ADDENDUM NO: 03

DATE: **Thursday – November 19, 2026**

PROJECT: **MSU Hamilton Hall Life Safety System Improvements** Bozeman, Montana

A102

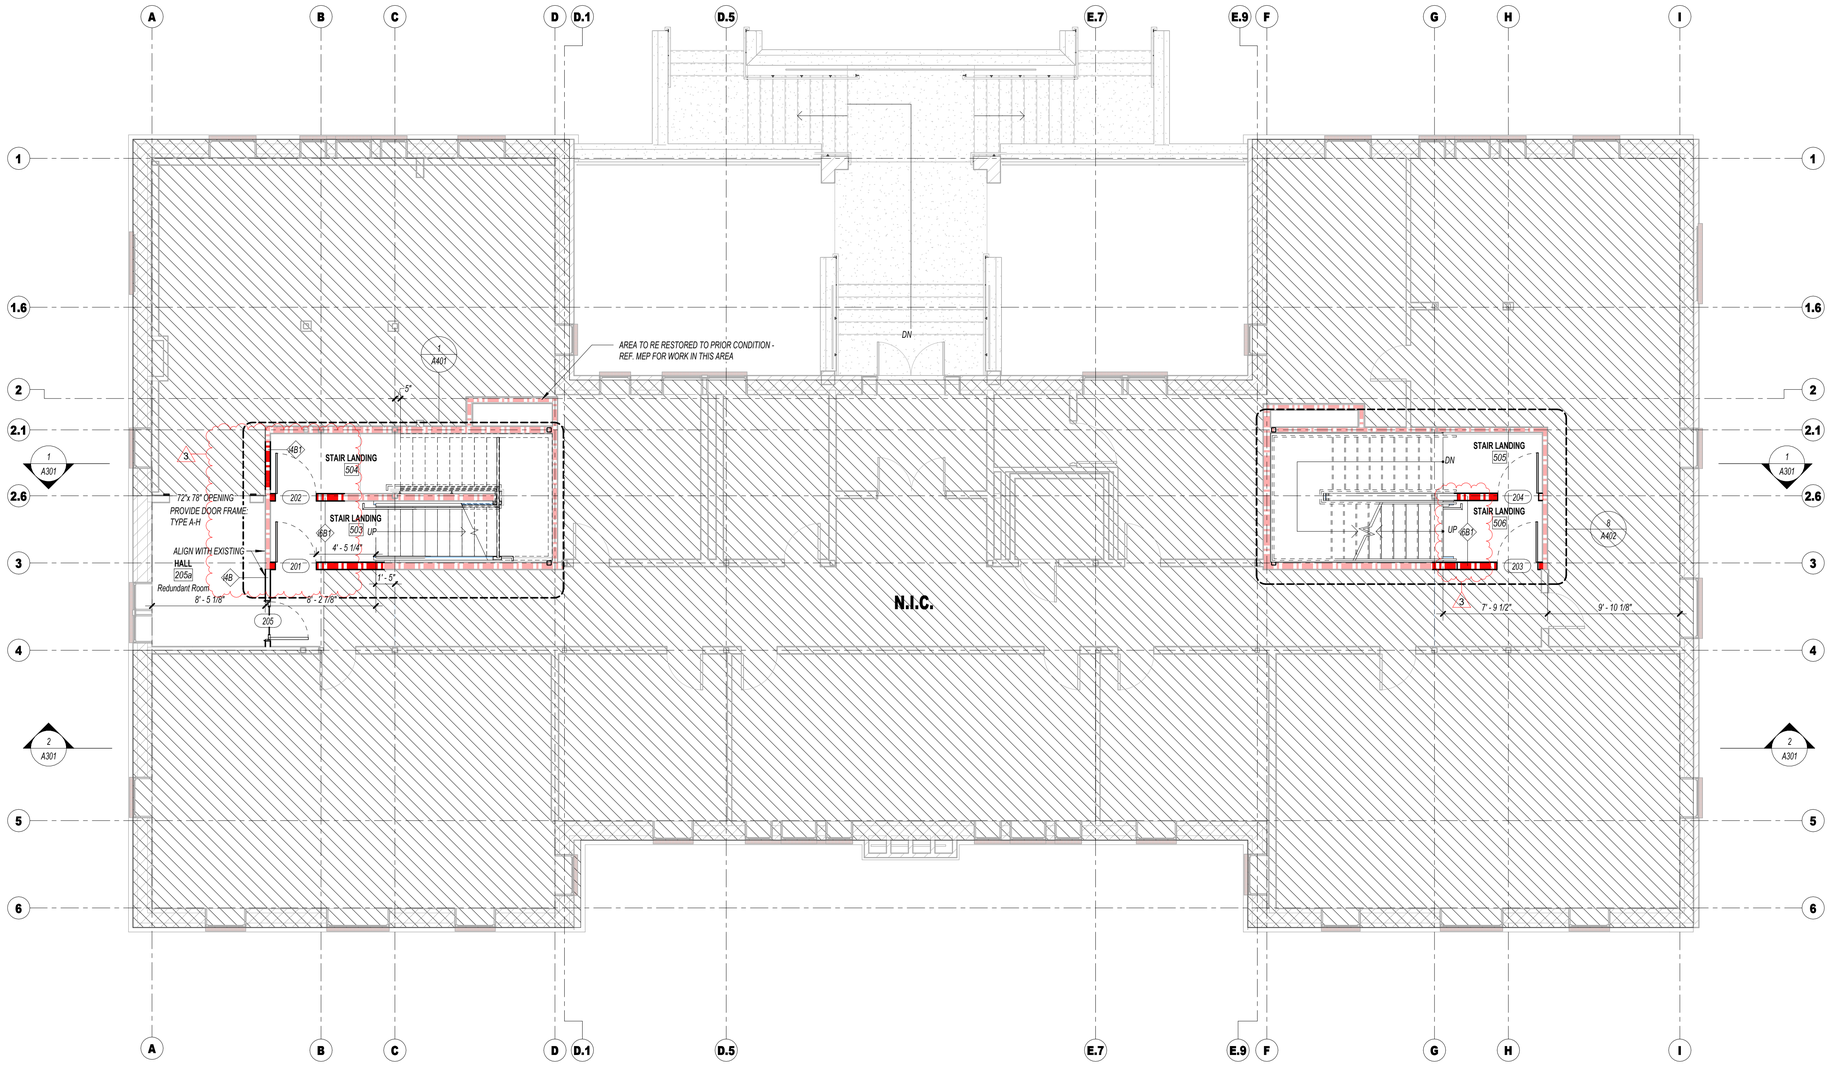
13. Question: On sheet A102 there is an additional ceiling being removed that is not showing as new ceiling on A116. Response: See revised Sheet A102, ceiling is not being removed.

1. **Sheet A004 –** See revised sheet.
2. **Sheets A102 –** See revised demolition plan.
3. **Sheet A112 –** See revised 2nd floor plan.
4. **Sheet A113 –** See revised 3rd floor plan.
5. **Sheet A114 –** See revised 4th floor plan.
6. **Sheet A115 –** See revised Attic plan.
7. **Sheet A116 –** See revised 2nd floor RCP.
8. **Sheet A117 –** See revised 3rd floor RCP.
9. **Sheet A118 –** See revised 4th floor RCP.

A112

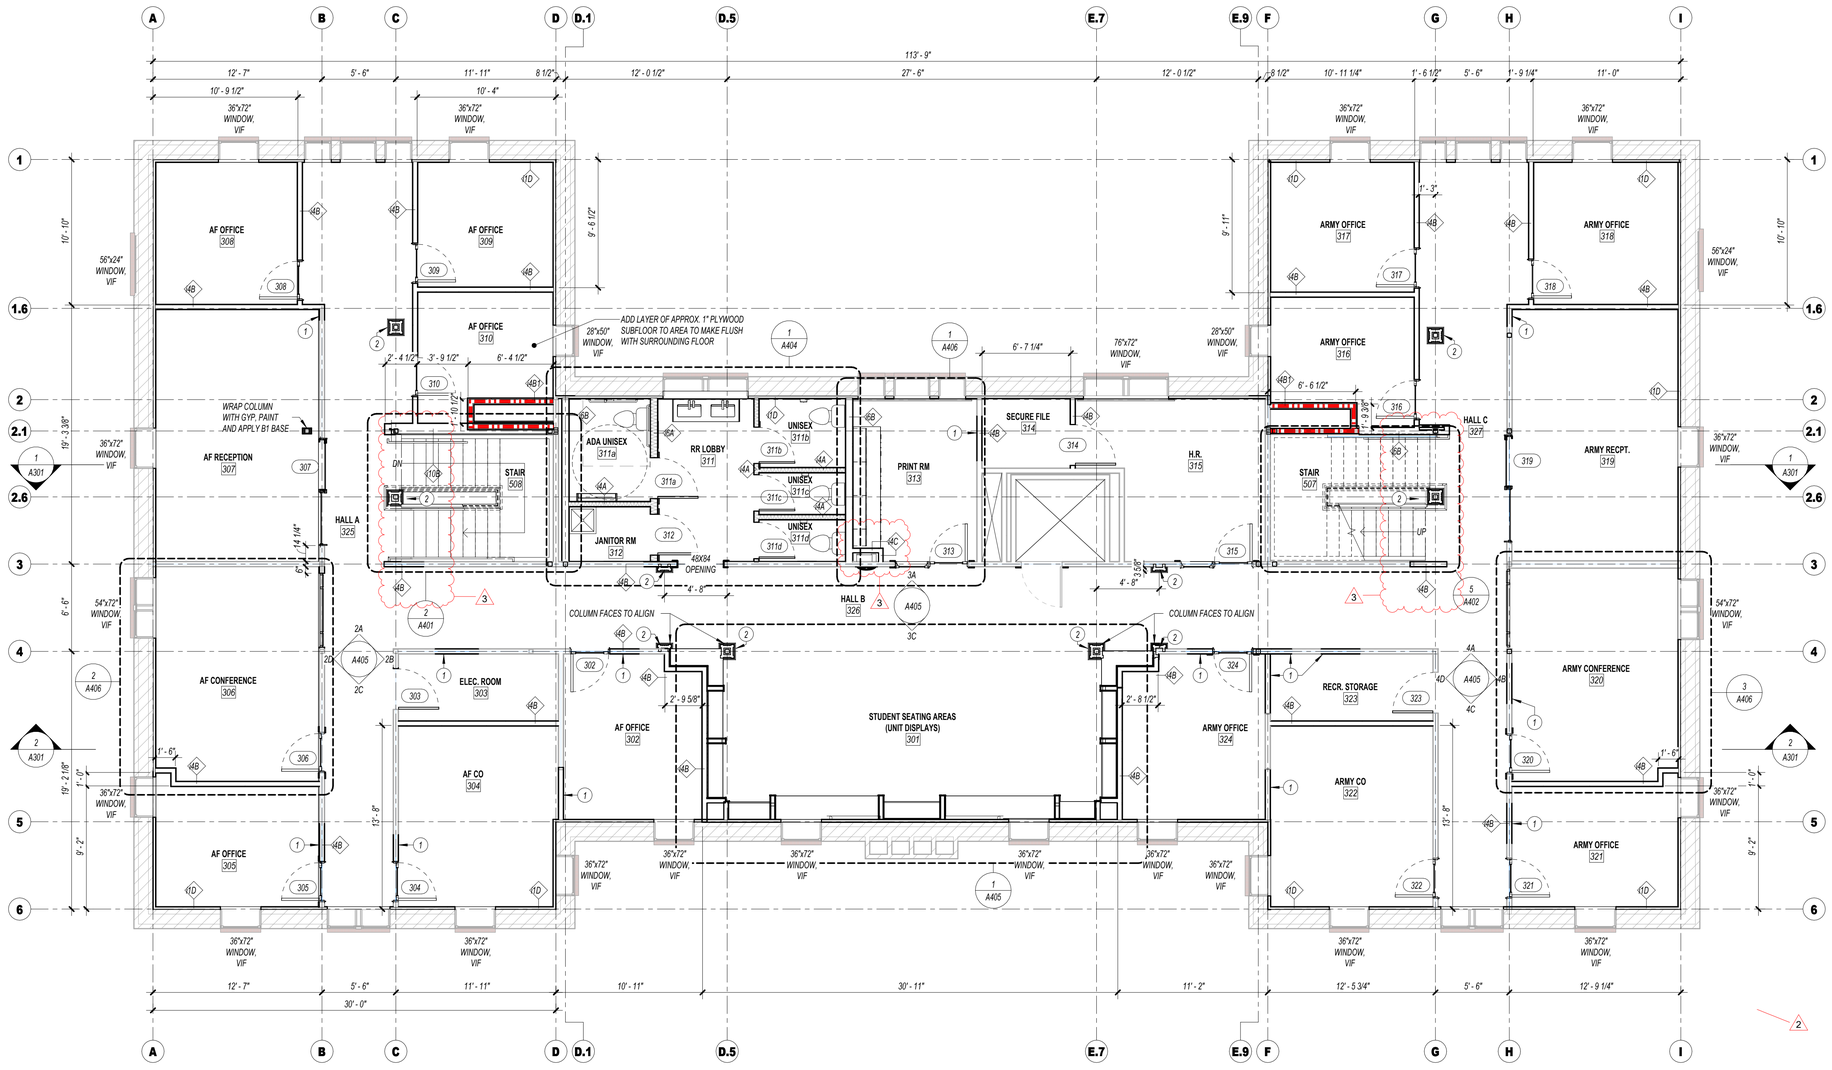
5. Question: The wall type for the smaller stair well is also not called out on A112. What wall type is this? Response: See revised Sheet A112 for correct wall tags.

7. Question: Could you please provide wall types on sheets A112, A113, A114, A115. Response: See revised Sheets A112, A113, A114 and A115 for correct wall tags.

A113

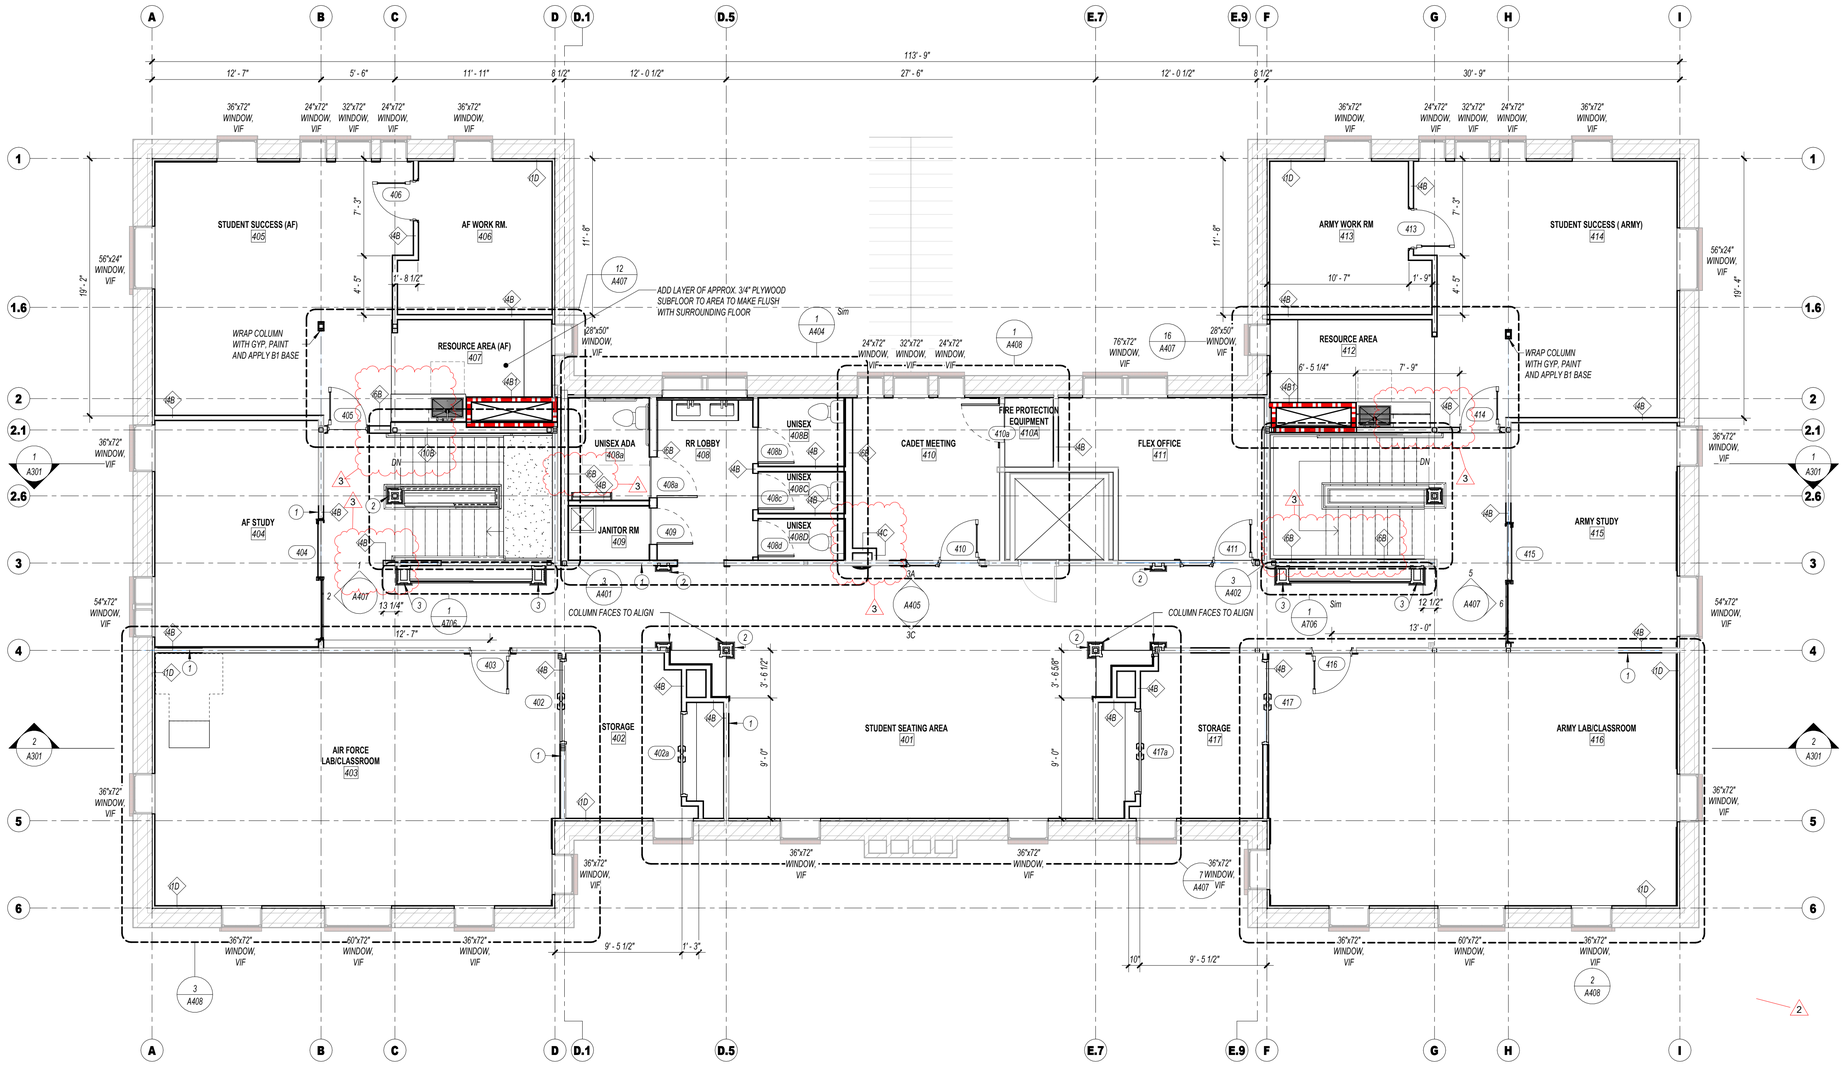
6. Question: What wall type is I2 on sheet A113? I could not find wall type I2 on sheet A104. Response: See revised Sheet A113 for correct wall tags.

12. Question: On sheet A004 has a wall type i#C shown, however I was unable to find these wall types called out. Response: See attached sheets for locations of wall type i#C. See attached Sheets A113 and A114.

A114

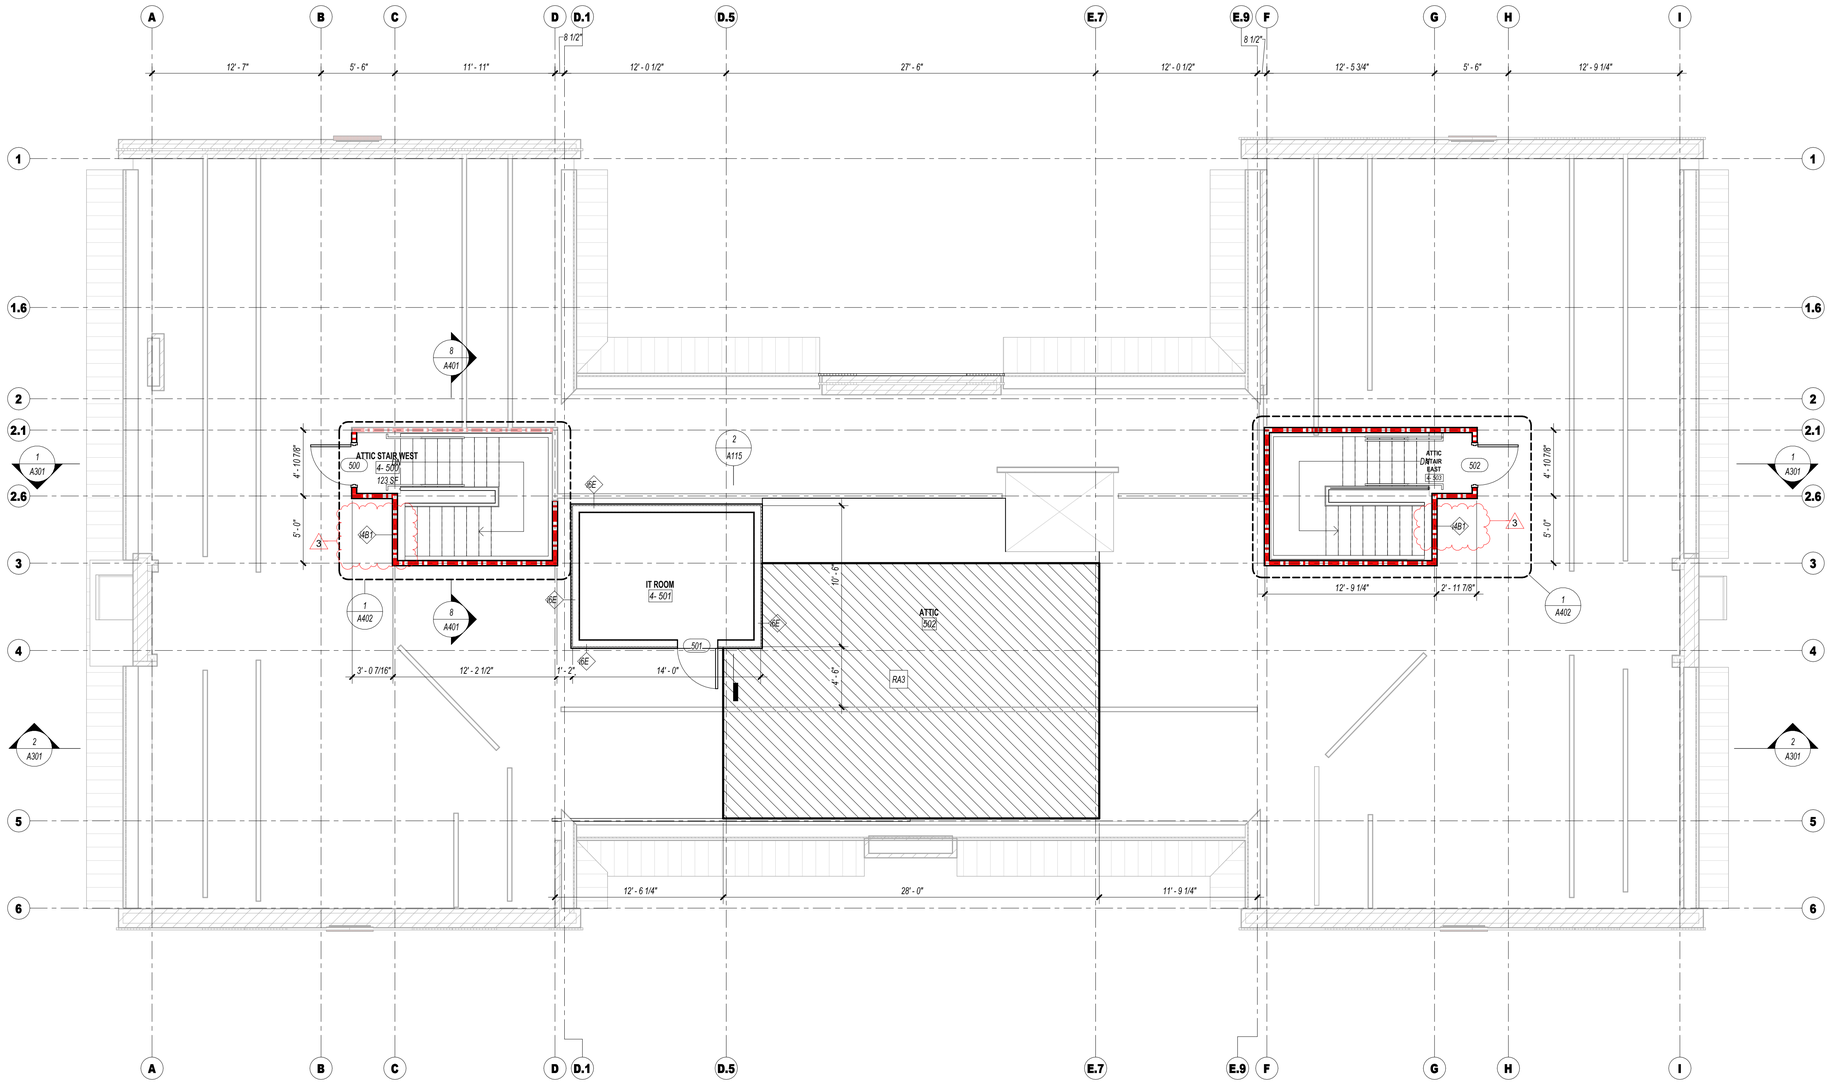
8. Question: Should the column in the East stair well on level 4 have a keynote 2 callout for a 5/A708 architectural column? See sheet A114. Response: Yes, it should have keynote 2.

11. Question: On sheet A114 what wall type is the west wall of Unisex ADA 408a? Response: See revised Sheet A114 for correct wall tag.

A403

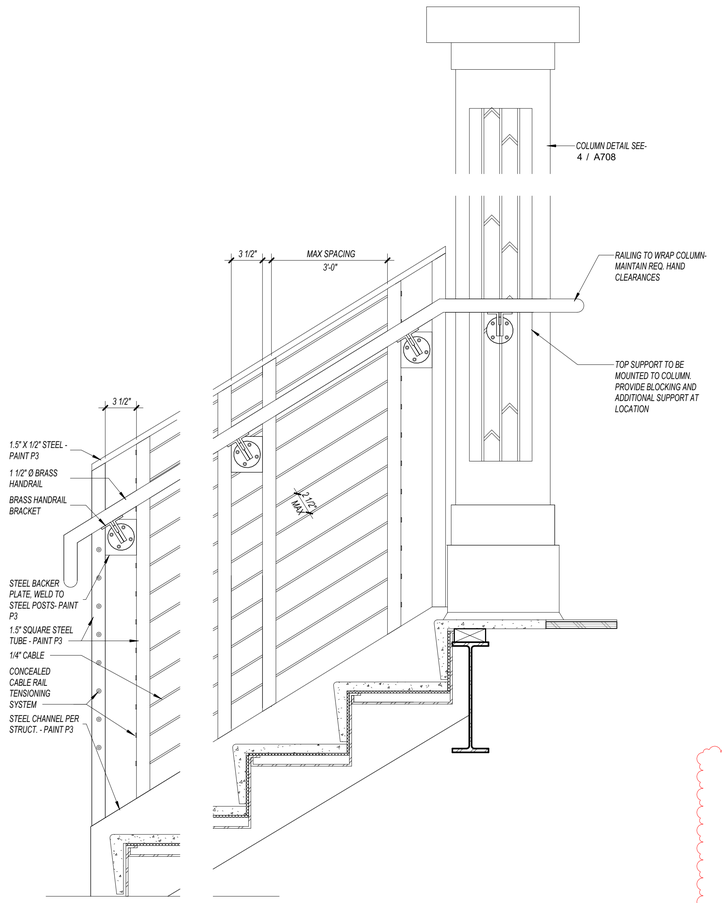
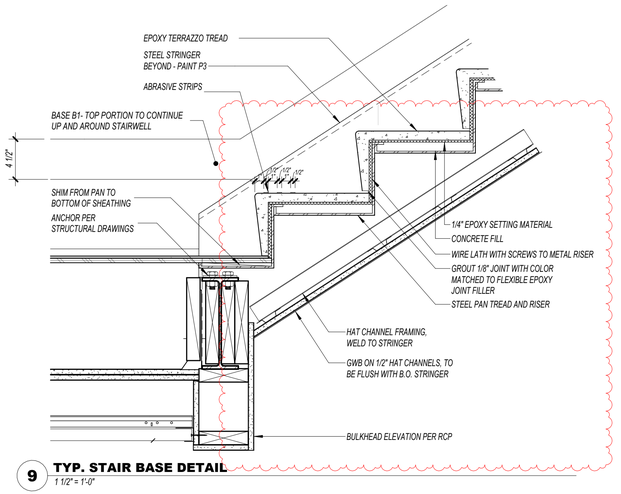
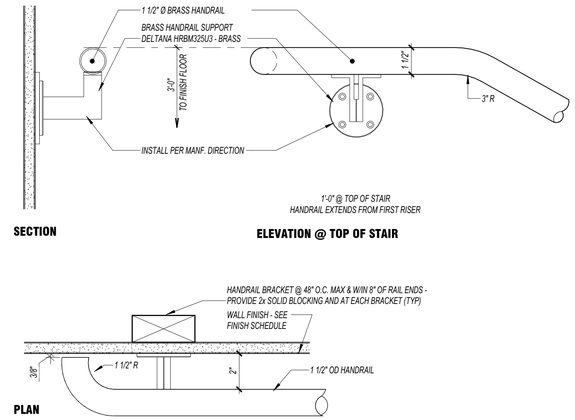
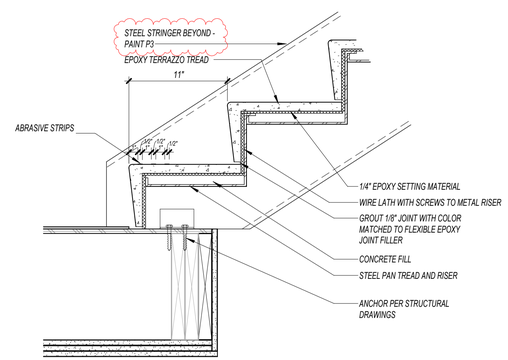
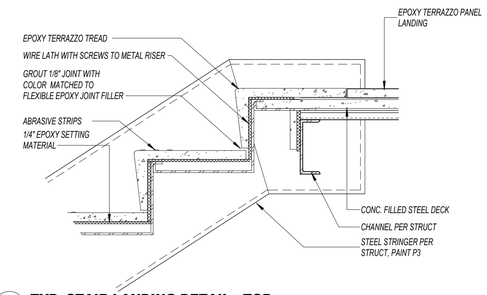
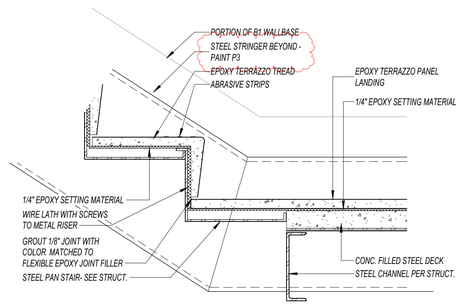
22. Question: Looking at the stairs and specifications for this project, details 6,8/A403 call for the stair stringers to be powder coated, but the rest of the details call for "paint P3." Looking into the specifications, the stair section calls for the stringers to be shop primed. The decorative handrail section calls for the steel handrail to be powder coated. Are the stairs and rails supposed to be powder coated or primed? Response: All steel to be primed and field painted.

10. **Sheet A403 –** See revised stair and handrails.
11. **Sheet A407 –** See revised 4th floor – Enlarged plans and interior elevations.
12. **Sheet A601 –** See revised Door & Window Types, Door Schedules.
13. **Sheet A702 –** See revised 3rd Floor Finish & Schedule.
14. **Sheet A703 –** See revised 4th Floor Finish & Schedule.

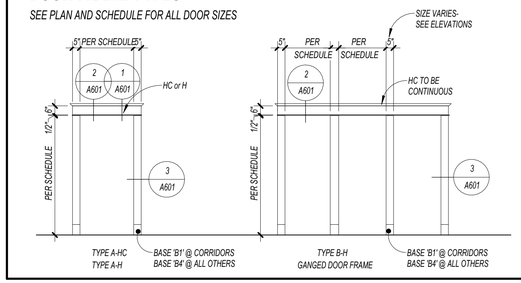
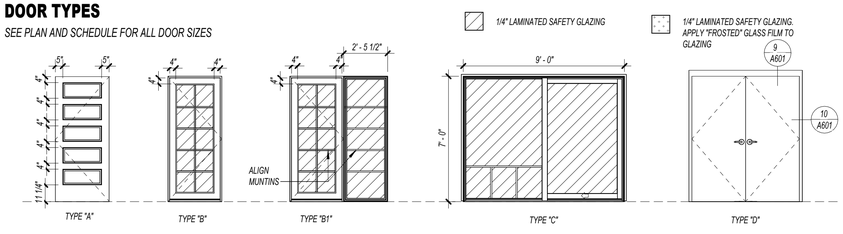
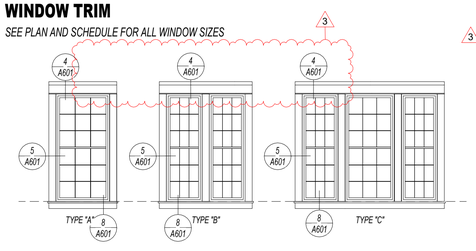
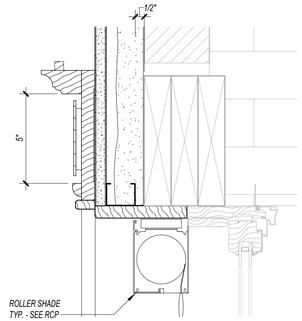
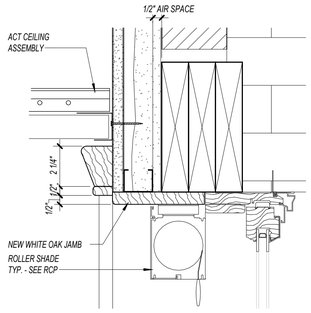
14. Question: On sheet A601 the trim types are identified by referencing the second half of the frame type designation (H and HC). However, there is a designation of 1 that occurs but there is no clear direction on the trim. What type of trim is needed for these frames HC or H? Response: HC, see revised Sheet A601.

15. Question: On A601, the window header trim on the window elevations has detail 9/A601 called out for Type A, B, and C. However, 9/A601 is the typical HM door type and doesn't make sense. Type A and B windows also have Detail 4/A601 called out for the header trim. Can 4/A601 be applied to window type C? Response: See revised Sheet A601.

17. Question: Sheet A/601 has a key/pattern for ¼" laminated safety glazing with frosted glass film. However, none of the window and door types have that pattern. Where does the frosted glass film go? Response: See attached Sheet A/601 for location of frosted glass film.
